**KANEPACKAGE PHILIPPINE INC.**

INVESTIGATION REPORT FORM (IRF)

Customer	BROTHER INDUSTRIES PHILIPPINES, INC.	Attention To	REXEL ALMARIO
Item Code	D037FX001	Department	PRODUCTION
Item Description	CARTON MFC-J4350DW EU-C	Date of Detection	250326
Job Order Number	JO-25-IPD-00414-1A	Section Detected	QA SCREENING

ILLUSTRATION OF THE PROBLEM

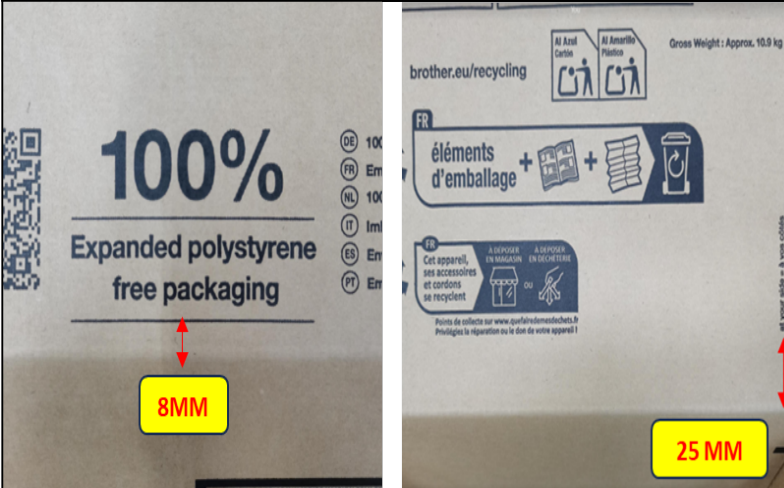
Lot Quantity (pcs)	Reject Qty (pcs)	Reject %
1300	49	3.77
Nature of Defect:		
MISALIGN PRINT		
Requirement:		
Acceptable up to 5mm print tolerance		
Actual		
Exceed printing tolerance

WHY 1 : Movement of print during process.

WHY 2 : Delayed timing/feeding of boards.

WHY 3 : Warp materials.

WHY 4 : Lacking of weight jig.

WHY 1: Provision of additional weight jig to prevent warping of materials. Paper weight jig already disposed as per advised of top management.
